**TO: Siskiyou County Government, Yreka;  
Analytical Environmental Services, Sacramento, consultants**

**FROM: Dr. Daniel Axelrod, 2536 Muledeer Dr, Weed. CA 96094  
daxelrod@umich.edu**

**RE: Crystal Geysers draft EIR comments, interested party**

**DATE: February 27, 2017**

Figure A

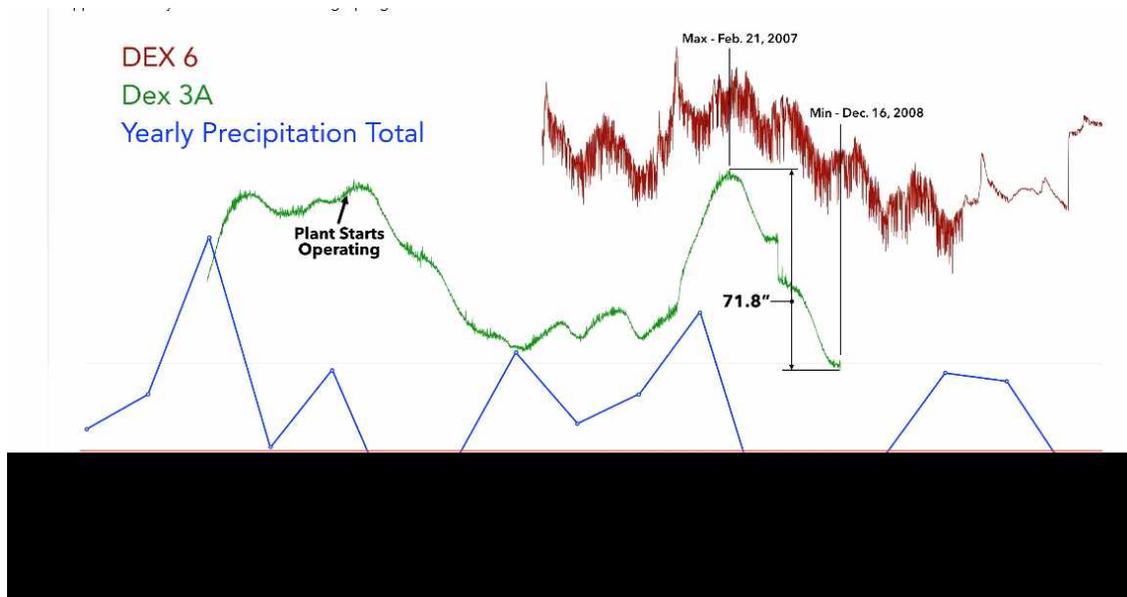
**Supp-3:** Fortunately, the public has had access to groundwater level records for DEX-3a, a shallower well drilled into the "upper" layer on CG property, data provided directly from by the RWQCB Central Valley region (see suppl doc 2, also shown below as Figure A). The green line is DEX-3a

It shows a 6 foot drop during the Feb 21, 2007 to Dec. 16, 2008, after which data is not available. Therefore, the assumption that we need deal with a single aquifer (the lower) to model effects of pumping (implicit in the use of the PUMPIT program, discussed below) is not justified and ignores the groundwater levels in the very layer (the alluvial one) accessed by neighboring residential wells.

Fortunately, as mentioned before, we have acquired (directly from the RWQCB) the DEX-3a data set, which does exist but the DEIR chose to ignore. That data (Figure A above) shows a drastic 6 foot drop during the years of pumping (see earlier comments with graph). **The EIR should and must include the essential data from shallow alluvial wells.** Numerous comments from residential neighbors have been made concerning a negative impact on their wells during those years of pumping, and no problems since pumping ended. **Those comments have been ignored.**

mention of the more relevant "upper aquifer" DEX-3a records (which we obtained from the RWQCB, Figure A above), which show a large decline in water level during the pumping years. **Mention of DEX-3a records would undercut the argument that "no mitigations are necessary".**

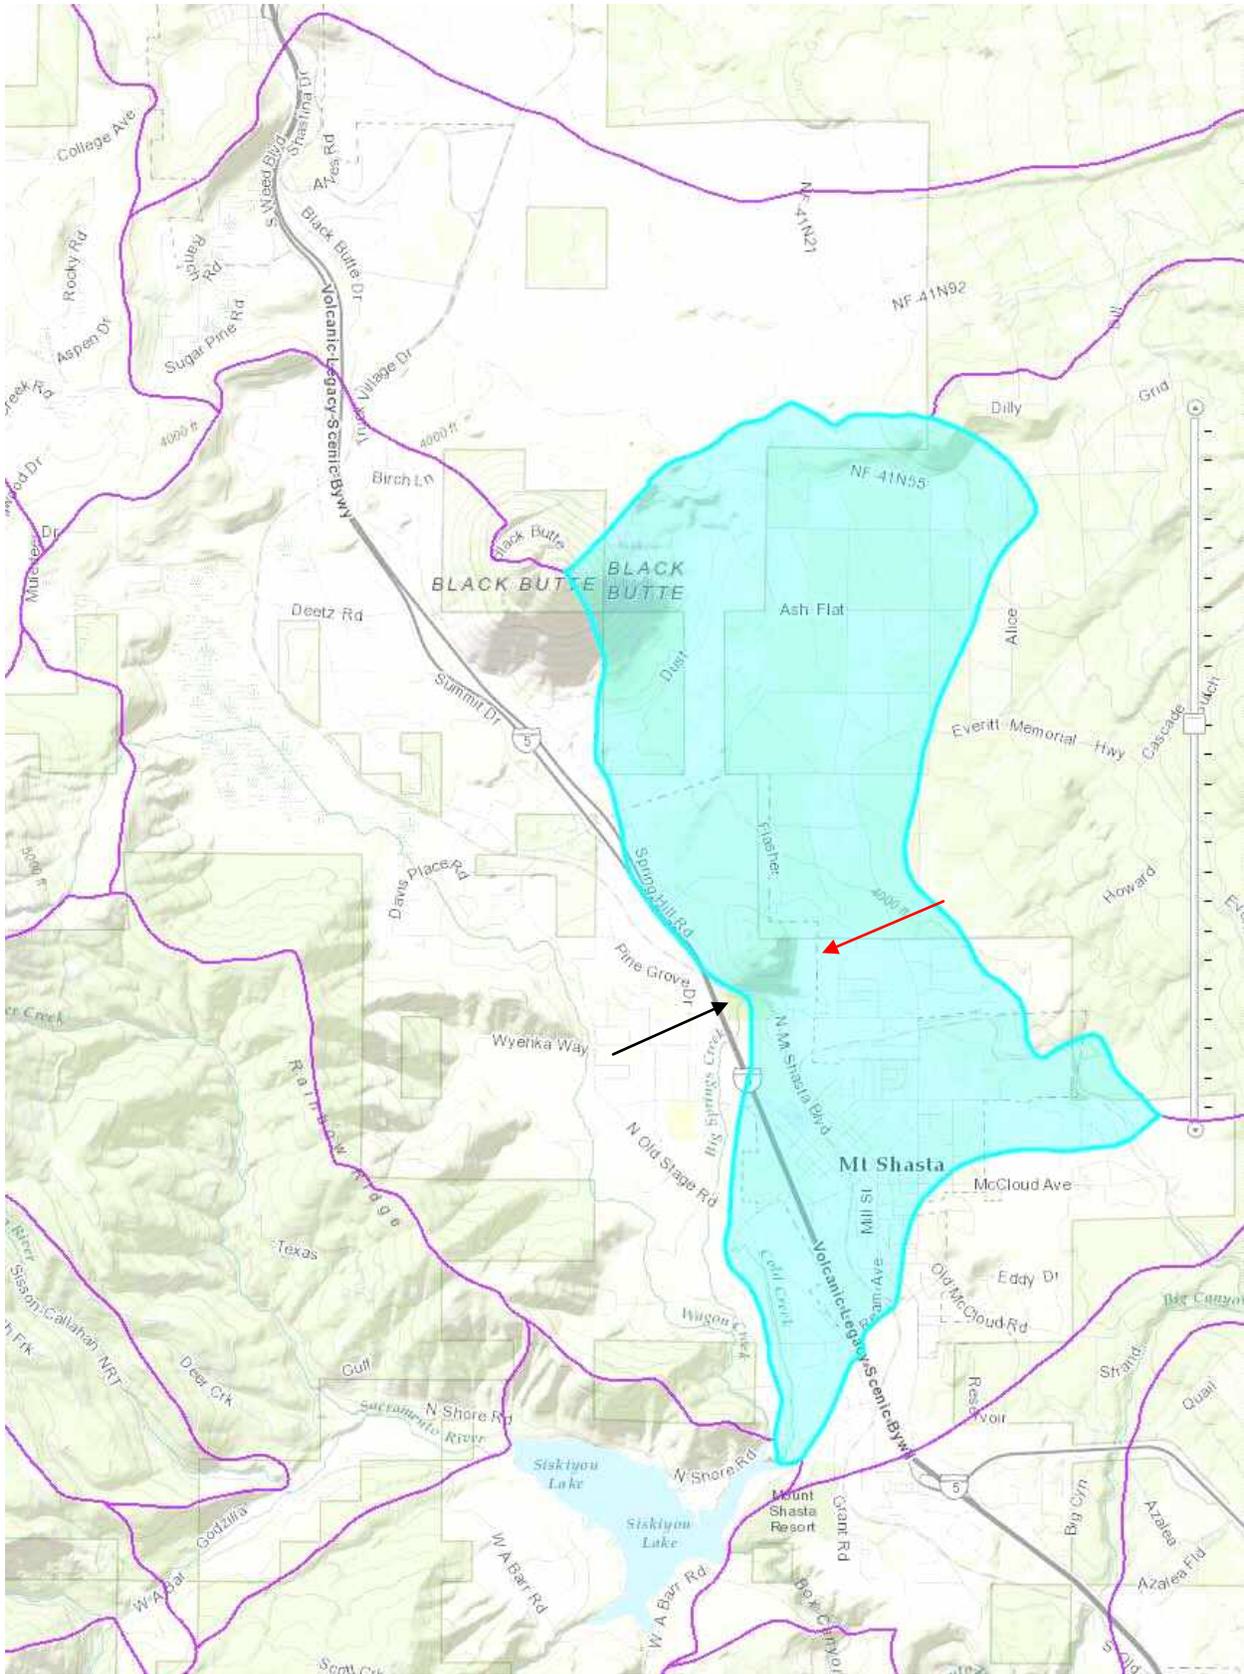
**Supp4:** The idea that surface topography determines the subsurface recharge area leads to some remarkable conclusions that contradict the whole thesis that DEX-6 and Big Springs share one big aquifer. The CA Dept. of Fish and Game has published a map of surface watersheds in the Mt. Shasta area (<https://map.dfg.ca.gov/bios/?al=Hydrography:10>), shown here:

The light blue area is the "Cold Creek" drainage, and it covers all of the CG plant. The location of DEX-6 is indicated by the red arrow. The distinctly different drainage just to the west (outlined in purple) is the "Big Springs Creek" drainage and it accepts all the water from Big Springs (black arrow). If we were to assume that surface topography determines subsurface recharge areas, then Big Springs would be disconnected for DEX-6, because they reside in different surface watersheds. Clearly, SECOR's citation of "*topographic map interpretation and use of Geographical Information System (GIS) software*" tells us exactly nothing about how recharge area was determined.

Figure B

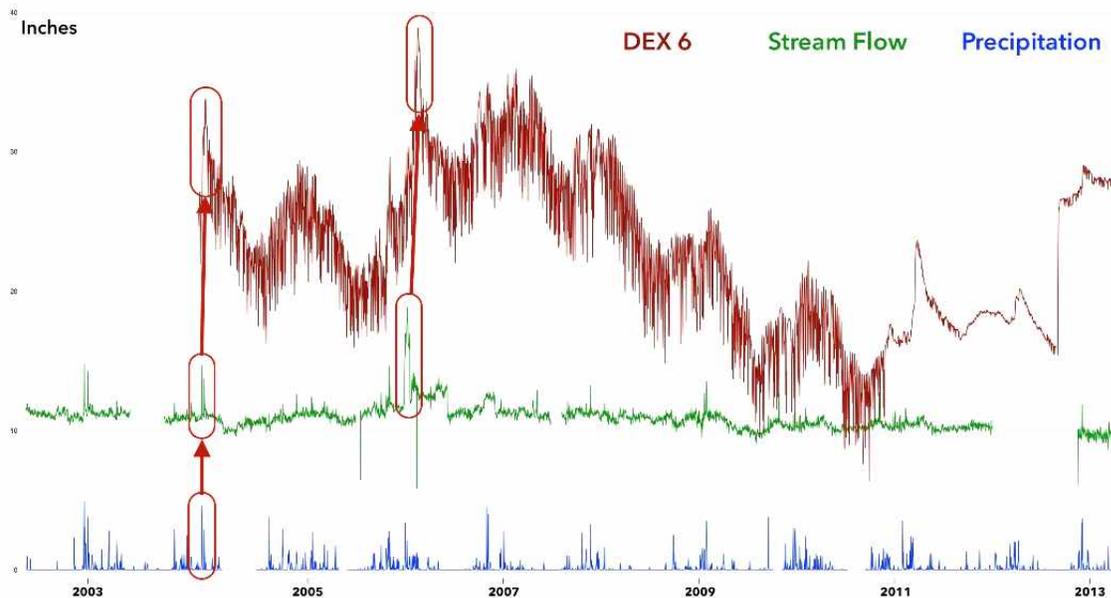
**AppP-Figure 6:** DEX-6, perforated in the deep "lower aquifer", shows groundwater level fluctuations over time that might give a clue to its sensitivity to industrial-scale pumping and to its connection with surface water and to the "upper aquifer". This is presented in Figure 6 of AppP, based on data acquired by Geosyntec, and replotted here with finer points to better show rapid fluctuations. The graph is plotted on the same time axis as measured Big Springs flow and precipitation events.

Here, Big Springs level is plotted correctly so that upward means "more water". The upward spikes in Big Springs level and precipitation also correspond to upward spikes in DEX-6 groundwater level, especially obvious in 2004 and 2006. This has important implications: (1) DEX-6 water level is quite sensitive, quite quickly, to surface water input, which contradicts the contention that it receives water only from the Appendix P - hypothesized "lower" aquifer; (2) If DEX-6 is hydraulically connected to water all the way up to the surface (at least to some extent), then DEX-6 could easily be hydraulically connected to water at intermediate depths (the "upper aquifer") which are those depths tapped by neighboring residential wells. In other words, with such a hydraulic connection, **there is a distinct possibility that drawdown of DEX-6 could affect neighboring residential wells. The DEIR does not make this point.**
